ADDENDUM DATE: March 11, 2024

## **ADDENDUM NO. 8**

### **Cobblestone Manor**

**Addendum No. 8** to the Drawings and Project Manual, dated June 8, 2023, Cobblestone Manor as prepared by Moody Nolan, Inc., 300 Spruce St. Suite 300, Columbus, OH 43215.

Description: Ghent PA2 Series Enclosed Fabric Bulletin Board w/ Lock  
2-Door, Shatter Resistant Acrylic Panels. Fabric interior panel.  
Long-lasting fabric hides pin holes  
Aluminum frame, Satin finish  
4' W x 3' H

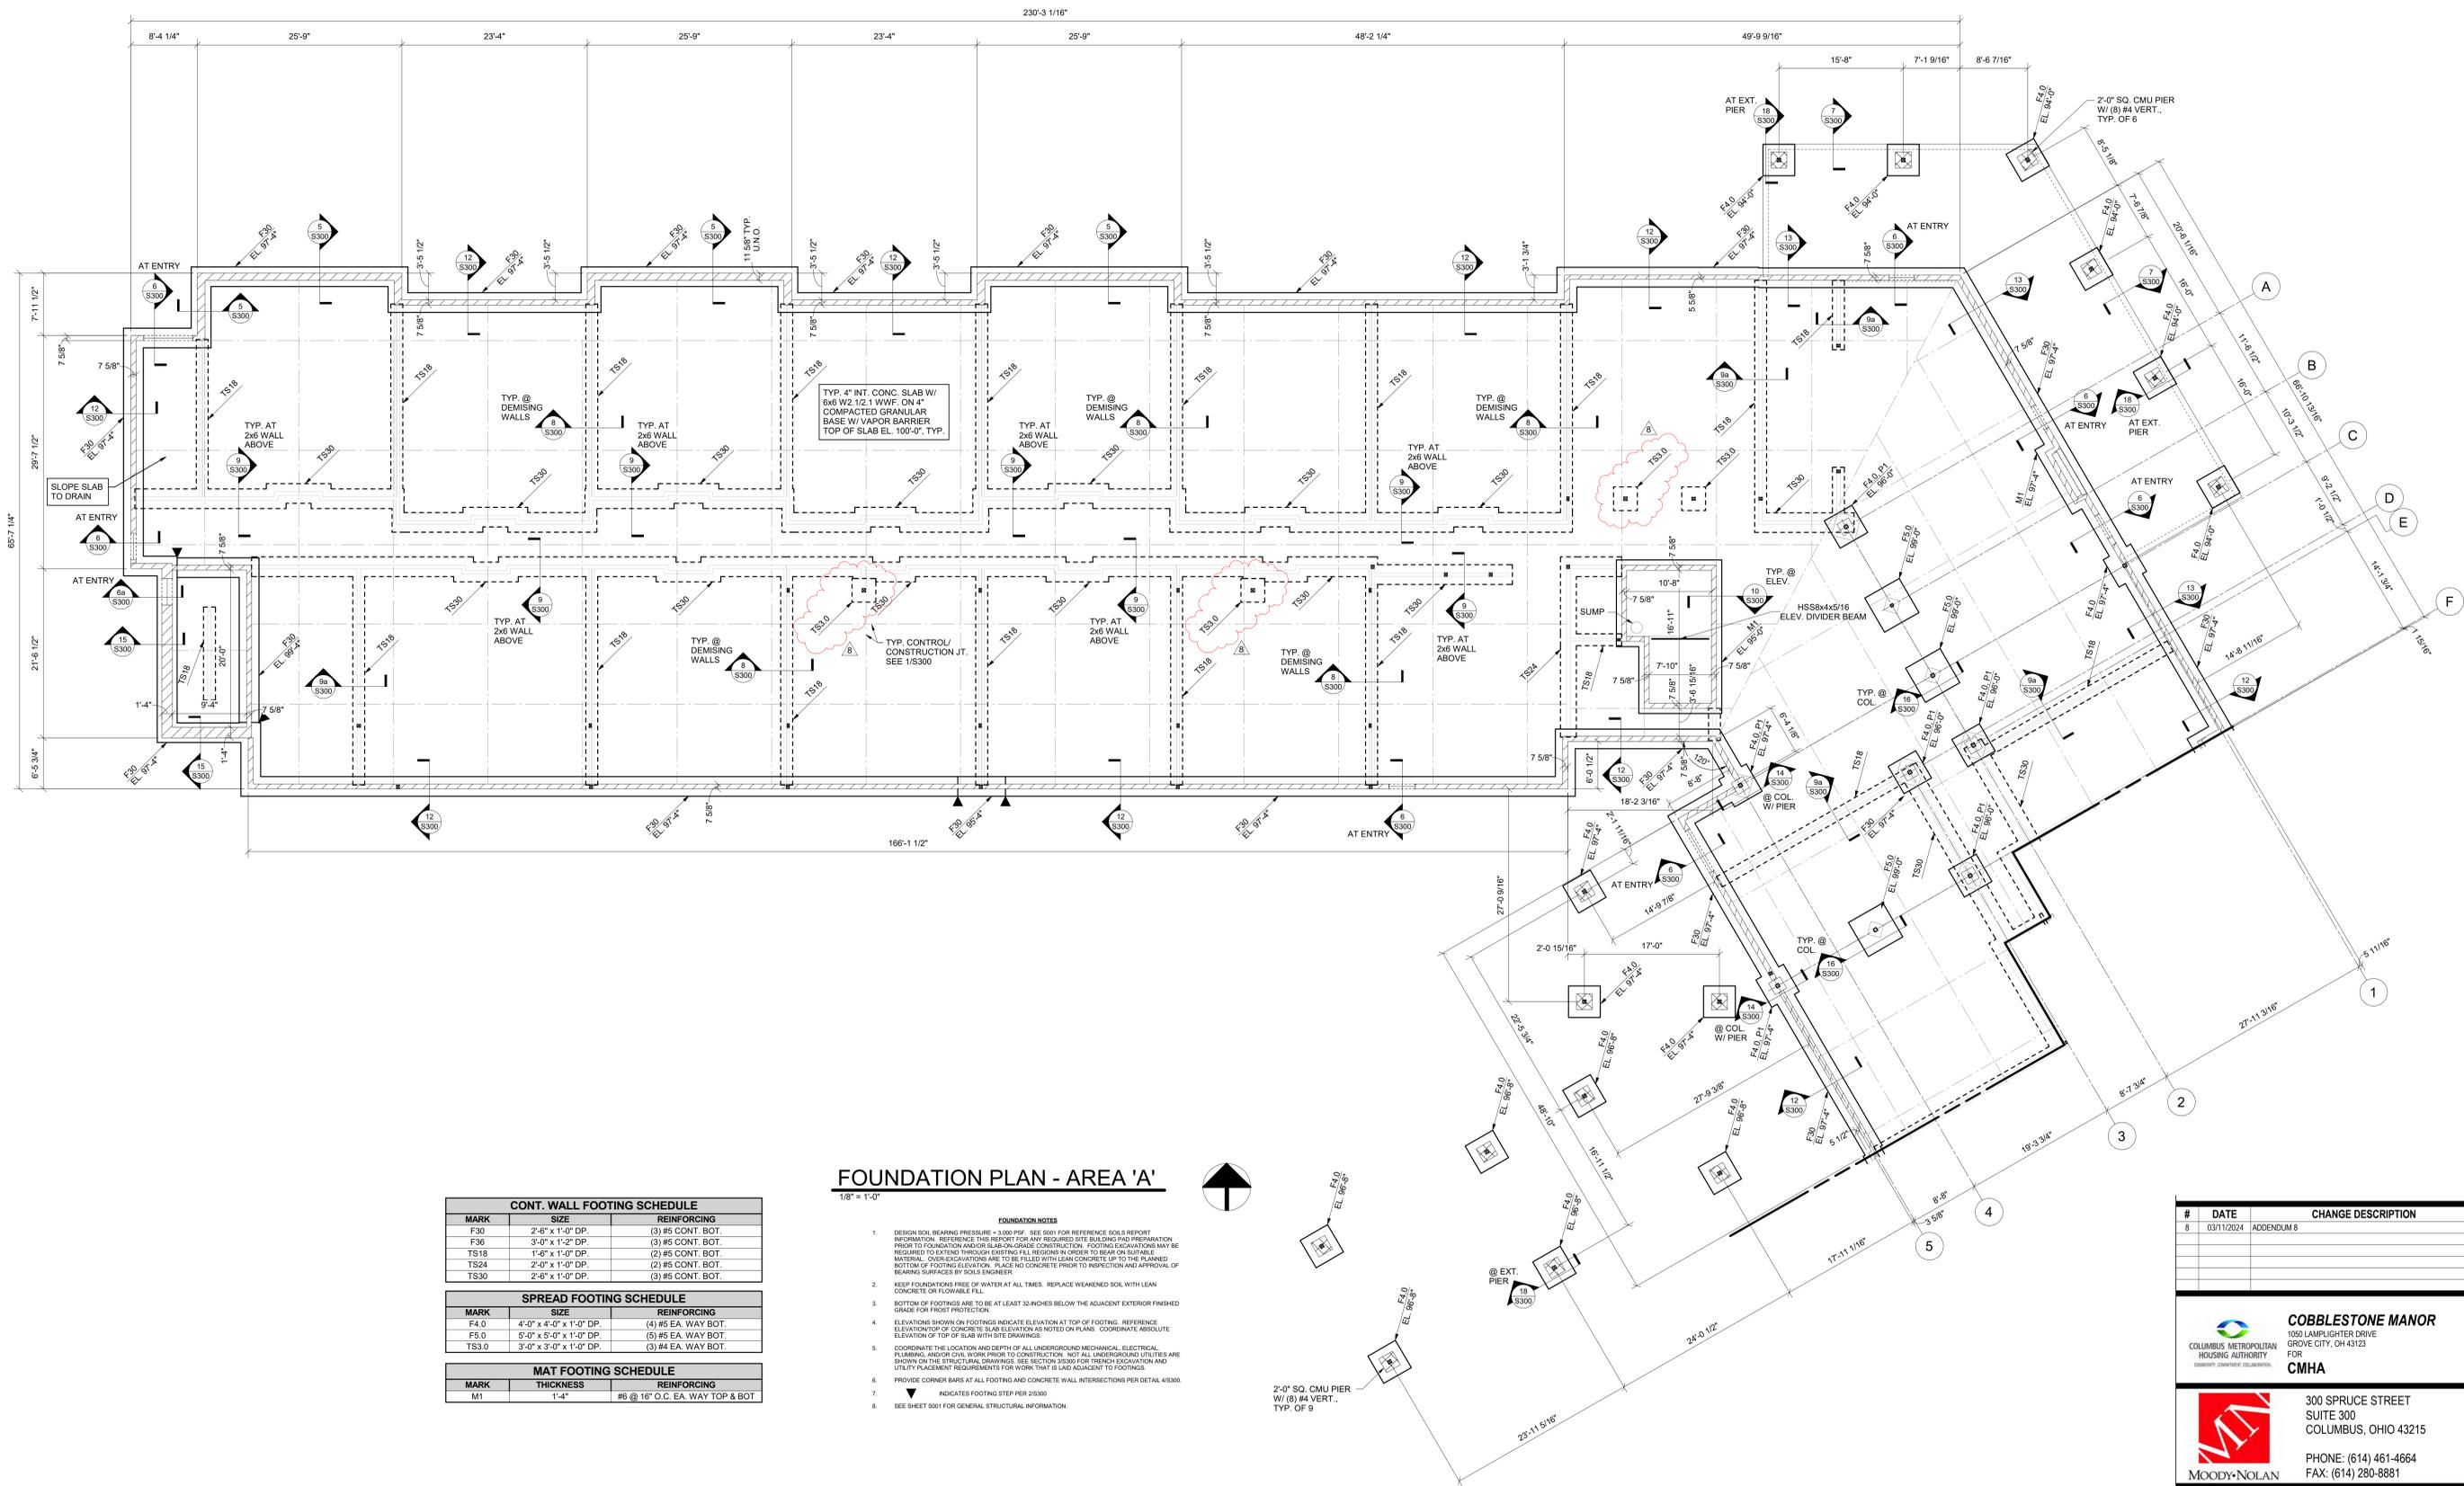
20. *Please confirm if the tackboard specified is the bulletin board (coded note 22) on sheet A801. If not, please provide tackboard sizing.*

1. **ADD** enclosed bulletin board product specifications to the FF&E listing.

**Response:** See attached enclosed bulletin board product specification.

DRAWING TITLE:  
**FOUNDATION PLAN - AREA 'A'**

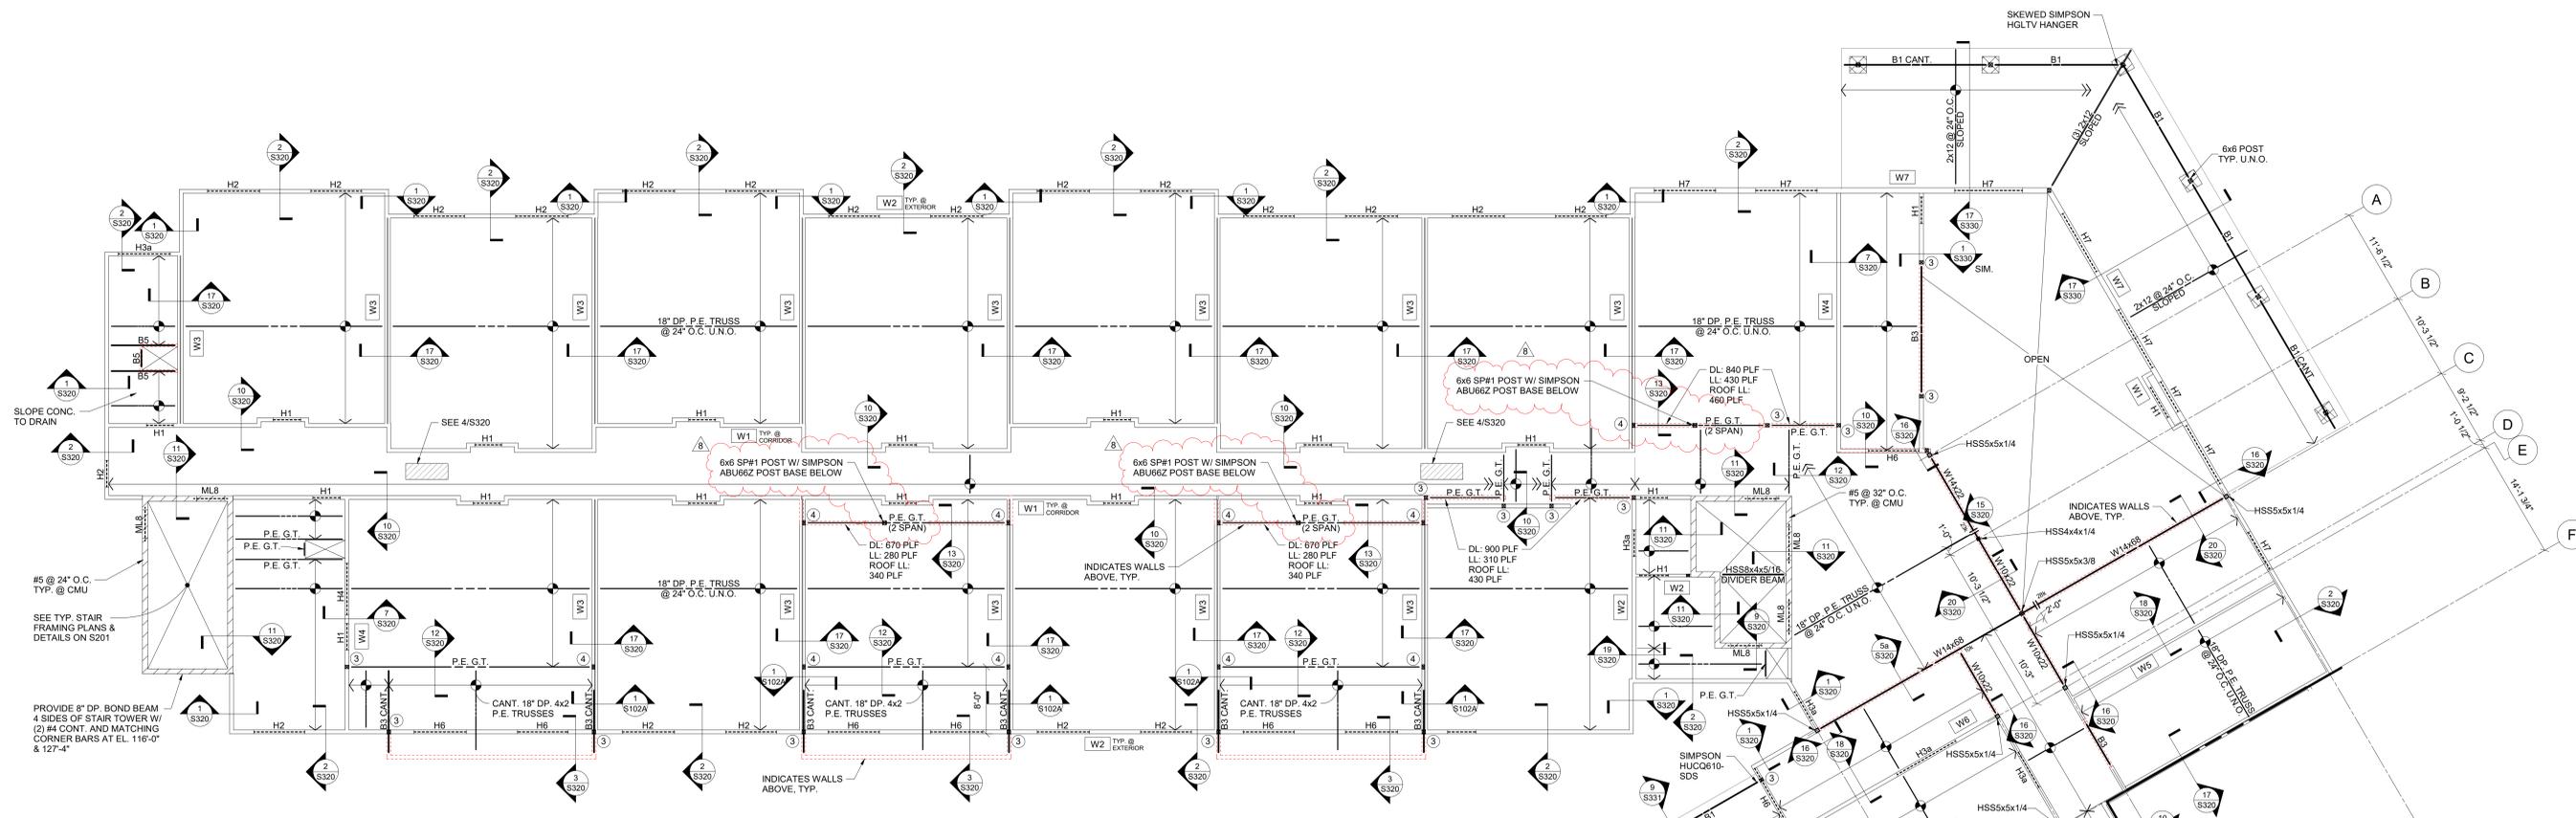
38. *On the 2nd floor there are several girder trusses supporting upper floor walls. The plans indicate the loads to be applied in these trusses. Girder trusses don't work with the loading shown on plans. Also, due to the loading, the maximum deflections limits are being exceeded. This truss is already 4 plies.*

A. S101A – FOUNDATION PLAN – AREA ‘A’

1. **ADD** (3) thickened slabs under (3) new 1st floor posts.

**Response:** Posts have been added in a few of the interior non-bearing walls to act as interior supports for the girder trusses that cannot handle the loads and spans as is. Thickened slabs have also been added to support the new posts. Refer to sheets S101A and S102A for details.

DRAWING TITLE:  
**SECOND FLOOR FRAMING PLAN - AREA 'A'**

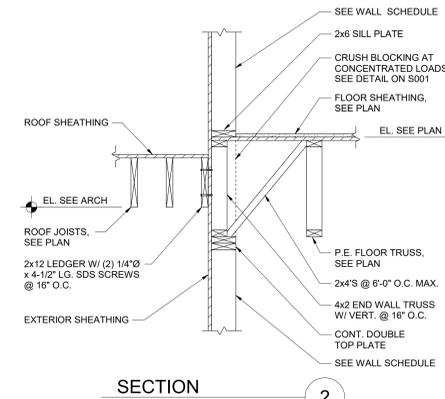
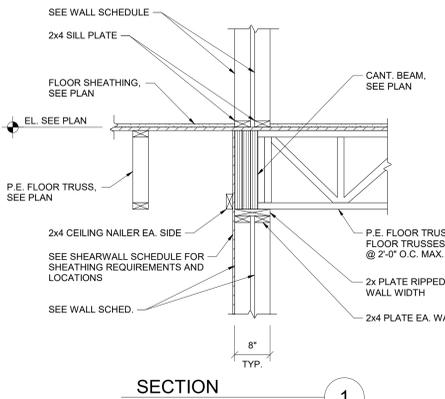
B. S102A – SECOND FLOOR FRAMING PLAN – AREA ‘A’

1. **ADD** (3) posts to the 1st floor to support corridor girder trusses per RFI#01 response.

SECTION 3  
3/4" = 1'-0"

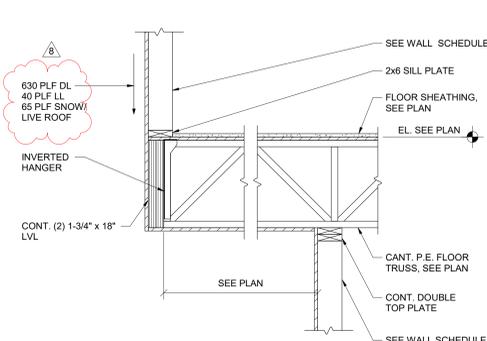
37. *On the 2nd floor there are several cantilever areas. In these areas there are floor truss girders trusses supporting the cantilever trusses. The girder truss as shown on plans and details does not work. The concentrated load at the end of the cantilever trusses is very high and it is creating an uplift due to dead+live load of 7,476 pounds and 4,344 pounds. This must be reviewed and verified if it is expected. Also, due to the loading, the maximum deflections limits are being exceeded. This truss is already 4 plies.*

1. **REVISE** Loading on cantilevered 2nd floor trusses in section 3 per RFI#01 response.

**Response:** The load on the 2nd floor cantilevered trusses can be reduced from what was shown prior to addendum #8 due to a G.T. that was added at the roof level that removed a significant amount of load from the exterior wall that was initially going to be picked up by the cantilevered trusses. While the G.T. was added after a progress set, detail 3/S320 did not get updated until addendum #8. Refer to revised sheet S320 for details.

**LEVEL 01 - FLOOR PLAN - OVERALL**

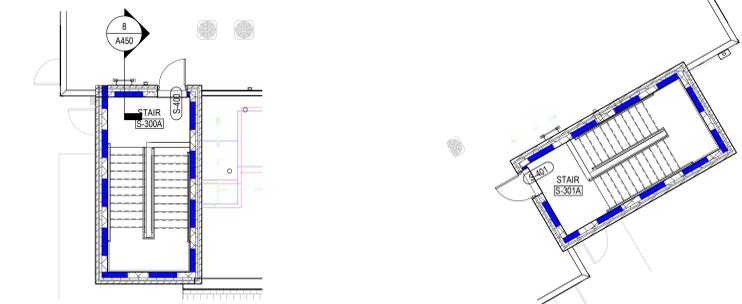
33. *Sheet A101 Floor Plan General Note FF:*

34. *Sheet A101 Floor Plan General Note MM – are corner guards required for corners in the corridor at unit door insets (examples highlighted below)?*

A. A101 LEVEL 01 – FLOOR PLAN - OVERALL

1. **REVISE** General Note FF to state. “PROVIDE AND INSTALL WINDOW COVERINGS AND HEAVY DUTY WINDOW SCREENS AT ALL RESIDENTIAL UNIT WINDOWS.”
2. **REVISE** General Note MM to state. “PROVIDE AND INSTALL CORNER GUARDS AT LOCATIONS AS NOTED ON THE PLANS.

3. **REVISE** General Note NN to state. "PROVIDE AND INSTALL CHAIR RAILS ON ONE SIDE AND HANDRAILS ON THE OTHER SIDE IN CORRIDORS AS SHOWN ON THE PLANS.

**Response:** Corner guards are only required as noted on the plans. General Note MM has been revised.

DRAWING TITLE: **ROOF PLAN - OVERALL**

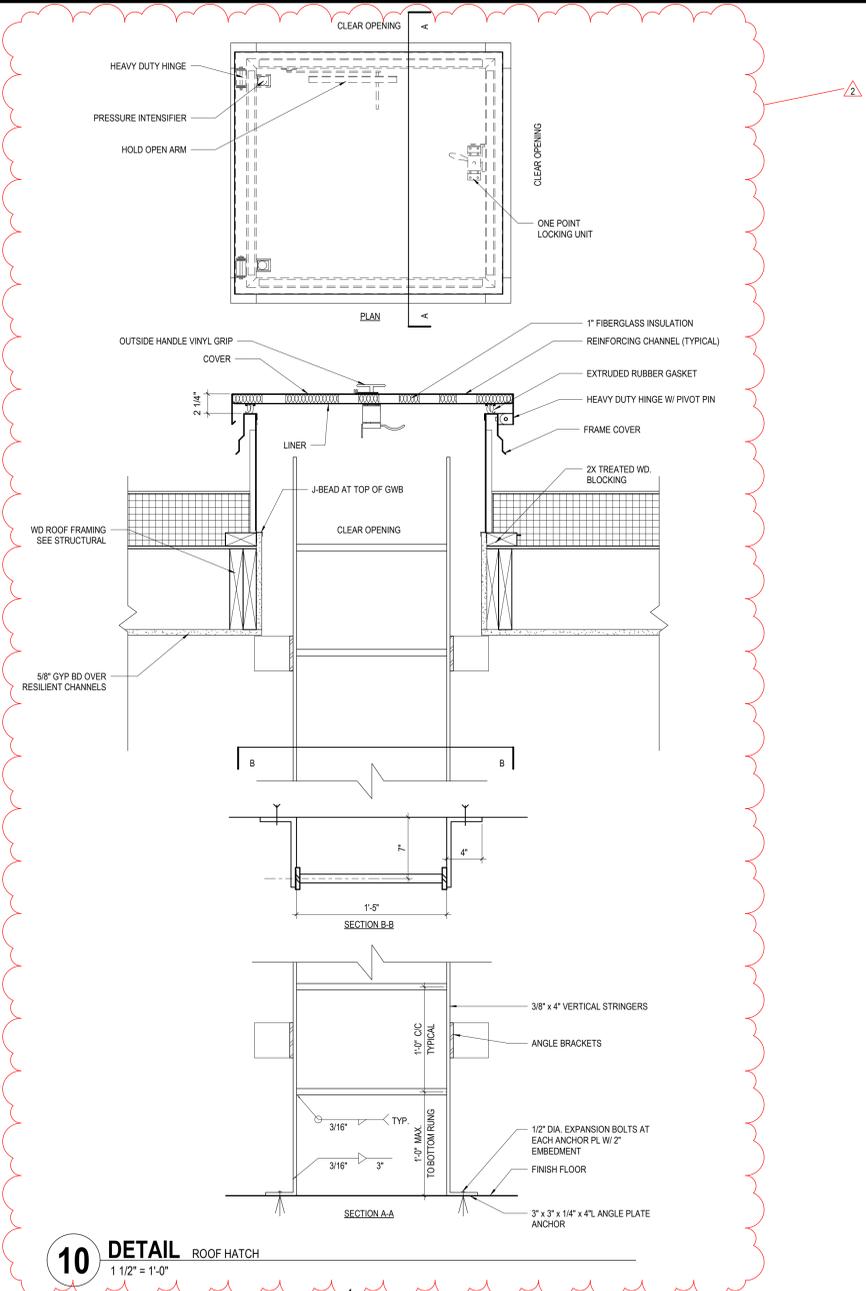
6. *Please provide details and height for mechanical roof screen.*

- C. A104 ROOF PLAN – OVERALL
    1. **REVISE** Coded Note 4 to state. "52" HIGH MECHANICAL ROOF SCREEN AND SUPPORT."
    2. **ADD** Coded Note 4 to the roof plan at the mechanical roof screen next to the elevator tower.

3. **ADD** Coded Note 16 to state, "2'-6" WIDE x 3'-1" DEEP ROOF HATCH & SAFETY RAIL – SEE DETAIL 10/A450."
  - D. A450 ROOF DETAILS
    1. **ADD** Detail 10/A450 ROOF HATCH & LADDER

**Response:** Provide a 52" high mechanical roof screen. Refer to specifications issued in Addendum 04.
